CONTRACT 26016

Building and Site Improvements at 6741 Downing Avenue, Bakersfield, CA

Bidder's Request for Information Responses #5

July 21, 2026

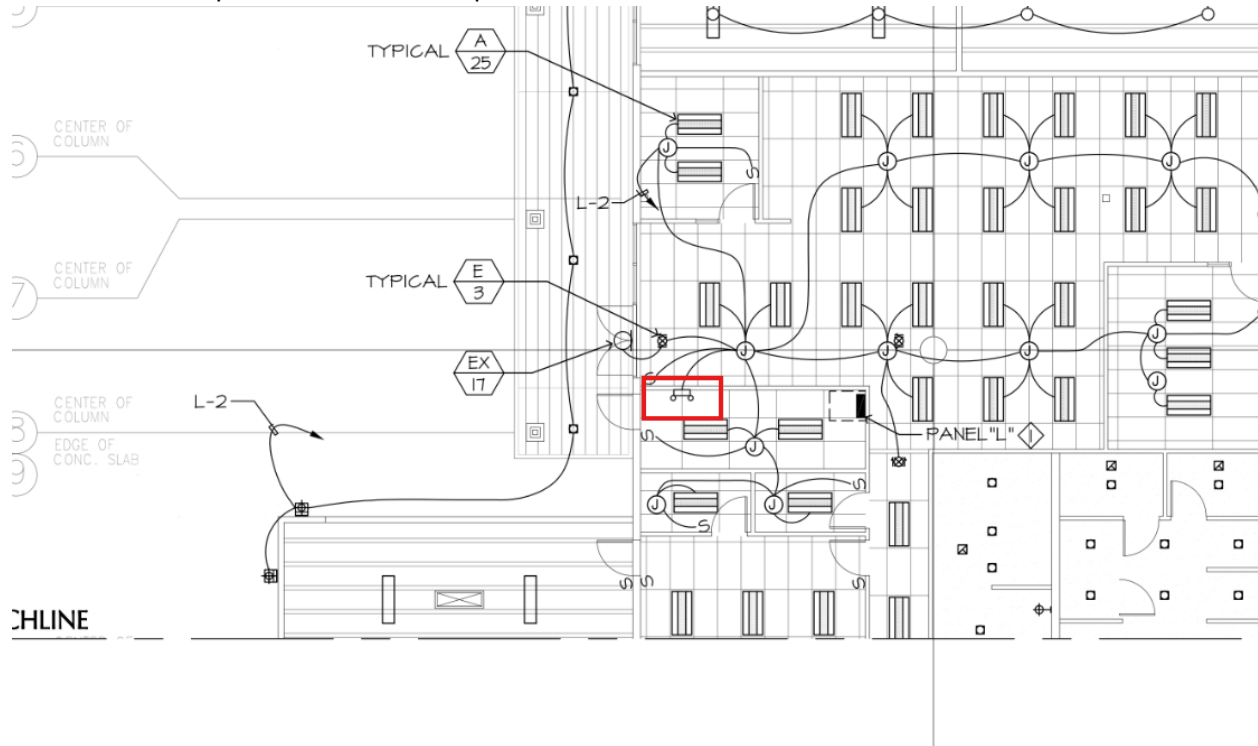
Per Sheet E311, who is responsible for providing & installing the 2-Ceiling fans?

Contractor is responsible for providing and installing ceiling fans. This information shall be added to sheet A311A under an addendum.

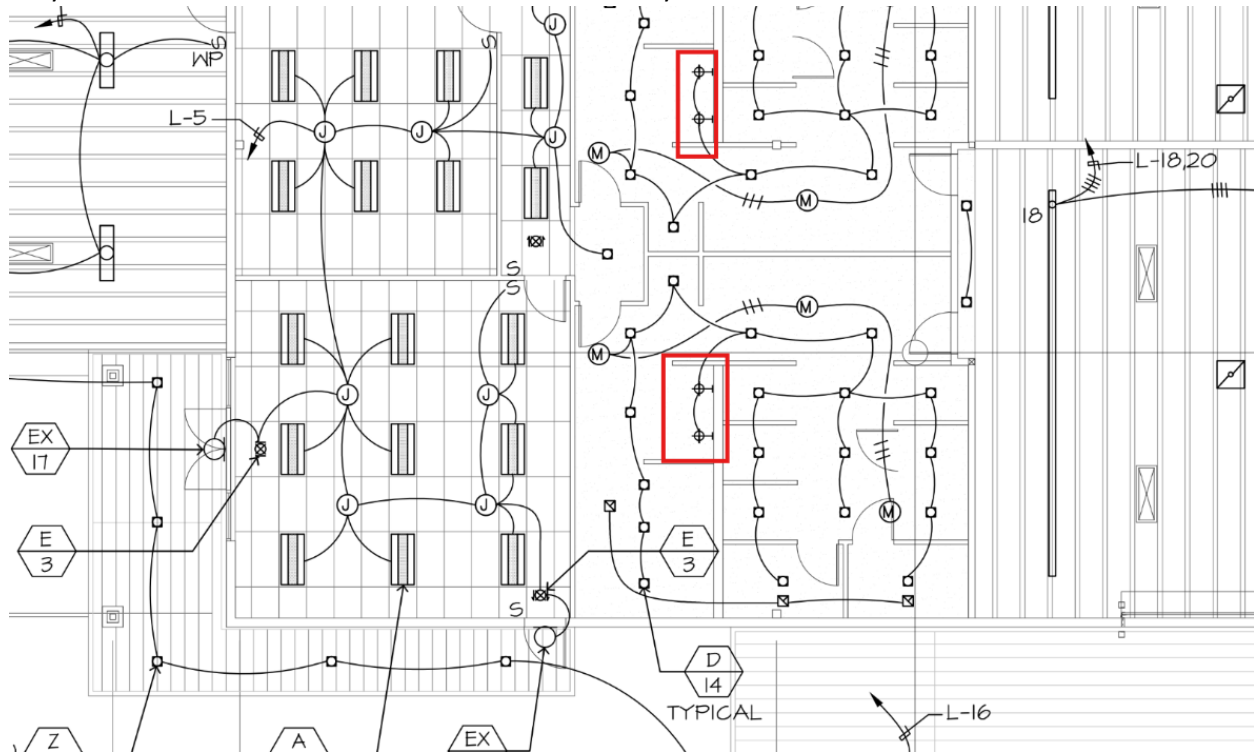
Is it acceptable to use different gear manufacturers other than squareD? (e.g. Eaton / Siemens).

Yes, alternative gear manufacturers are acceptable if they meet UL listing requirements and are equivalent to the specified gear manufacturer.
